### APPEAL SUMMARY

<b>Appeal ID:</b> 23284	<b>Project Address:</b> 5325 N Interstate Ave
<b>Hearing Date:</b> 1/8/20	<b>Appellant Name:</b> Ryan Miyahira
<b>Case No.:</b> B-007	<b>Appellant Phone:</b> 5032457100
<b>Appeal Type:</b> Building	<b>Plans Examiner/Inspector:</b> Chris Pagnotta, Corey Stanley
<b>Project Type:</b> commercial	<b>Stories:</b> 7 <b>Occupancy:</b> R-2, B, S-1, S-2 <b>Construction Type:</b> III-A over I-A
<b>Building/Business Name:</b> Interstate and Willamette Apartments	<b>Fire Sprinklers:</b> Yes - Full building
<b>Appeal Involves:</b> Erection of a new structure	<b>LUR or Permit Application No.:</b> 16-279600-CO
<b>Plan Submitted Option:</b> pdf [File 1] [File 2] [File 3] [File 4] [File 5]	<b>Proposed use:</b> Apartment - Multi Family residential

**Alternate 2 hour fire rated beam assembly with engineering analysis: Hold for additional information. Appellant may contact Corey Stanley (971 291-8919) with questions.**

Re: GLB Rated Beam  
16-279600-REV-04-CO #2

**1** **ROOF @ FOURTH FLOOR 2**  
3/4" = 1'-0"

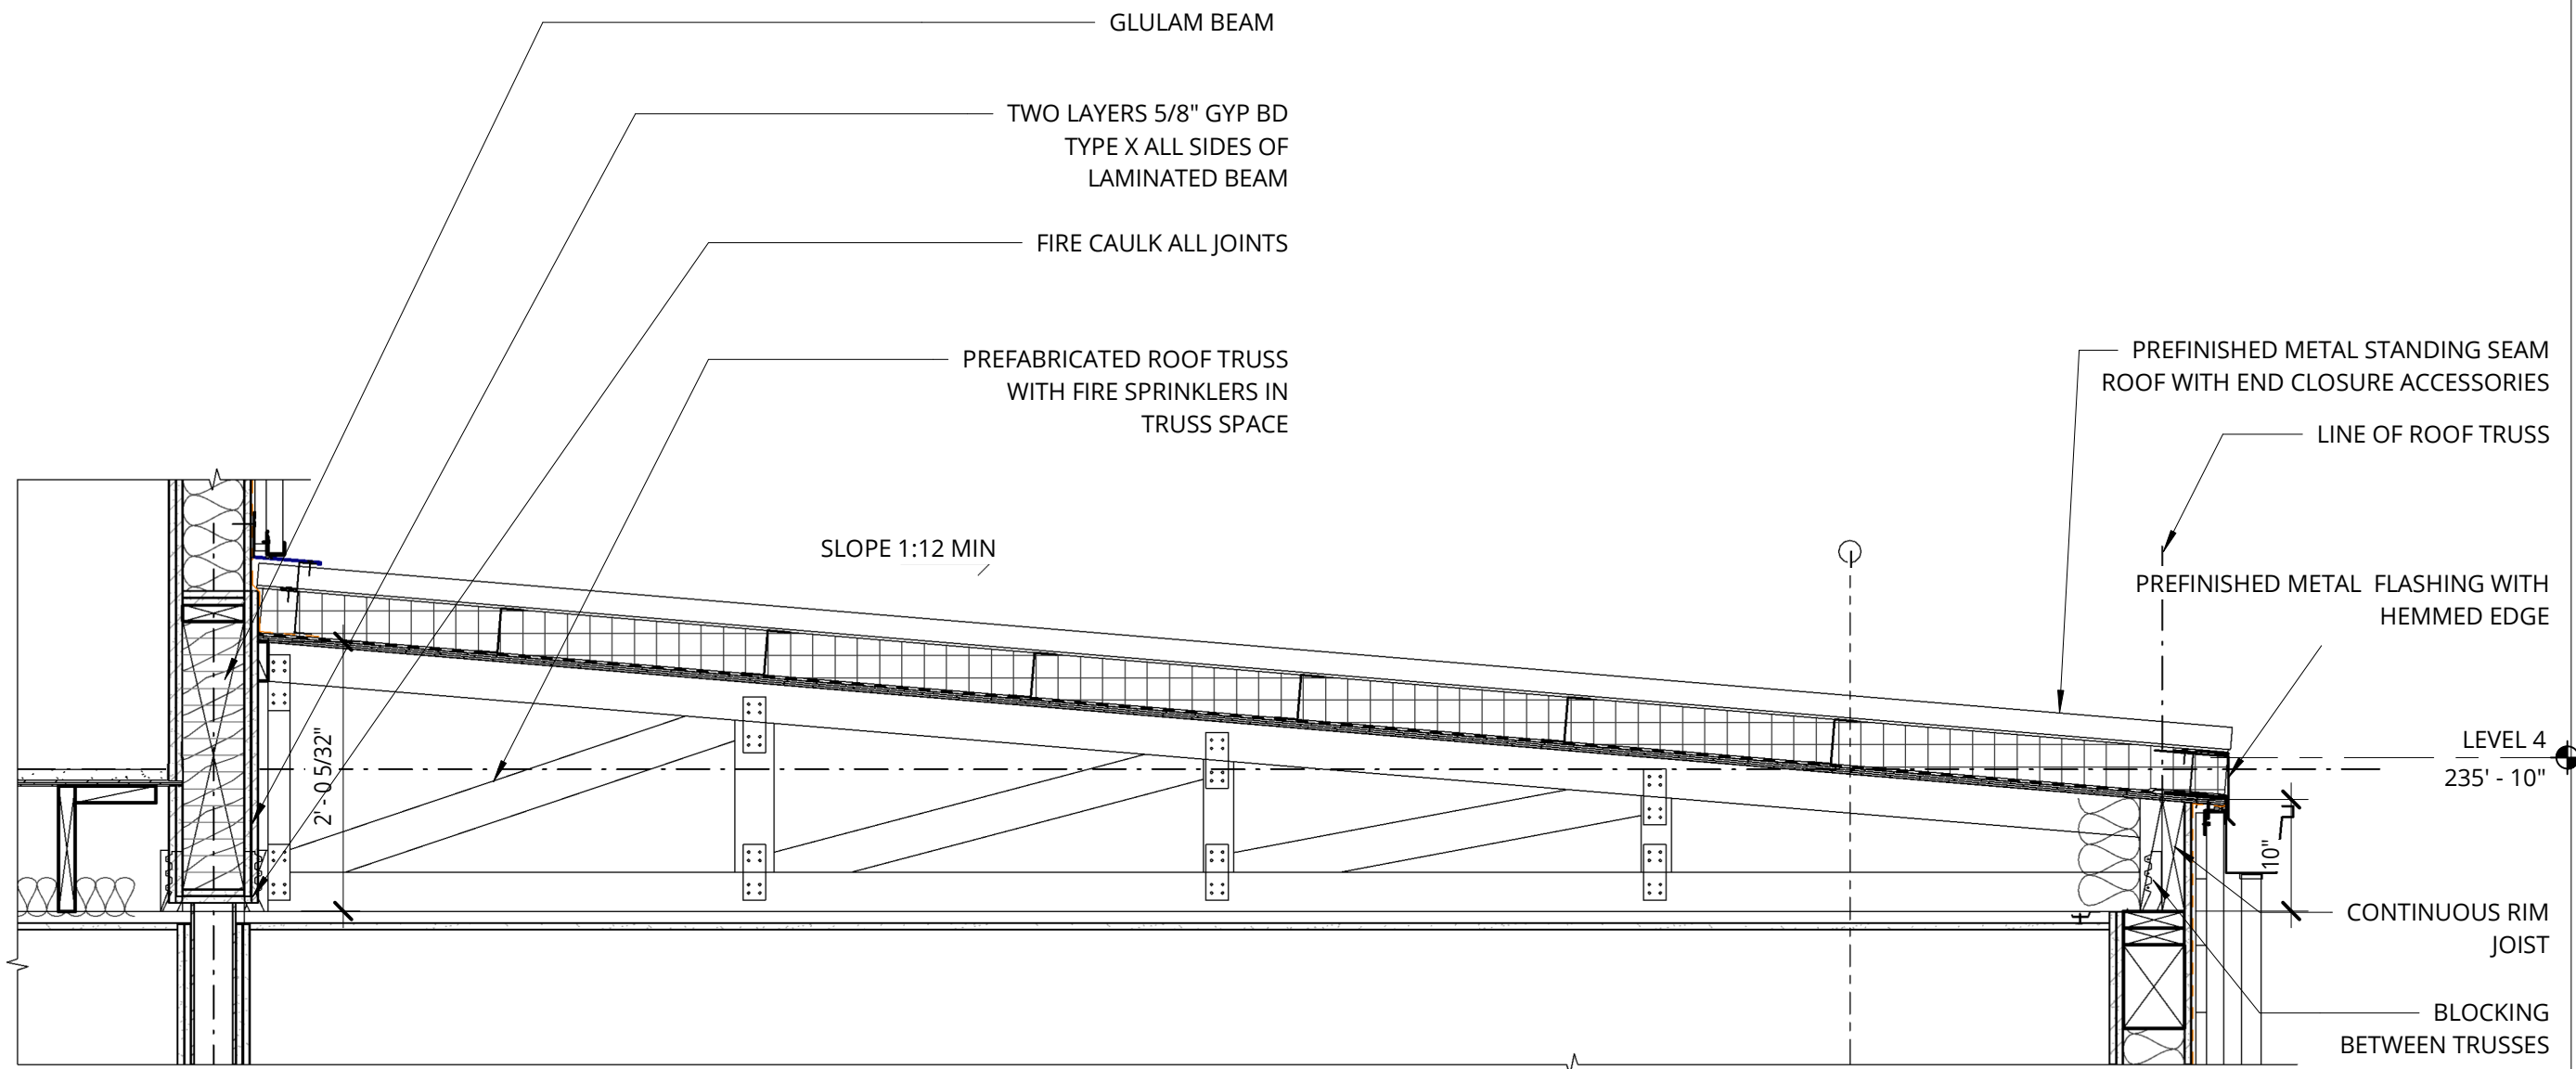
Wrapping the beam with two layers of 5/8-inch Type x gypsum wallboard to provide additional protection.

A char analysis of the beam prepared by the project structural engineer is enclosed showing the beams are adequate for 2-hour rating.

Fire sprinklers in the truss space open to the beam are provided.

**Reason for alternative** A non-fire treated glulam beam has been installed in the type IIIA portion of the building.
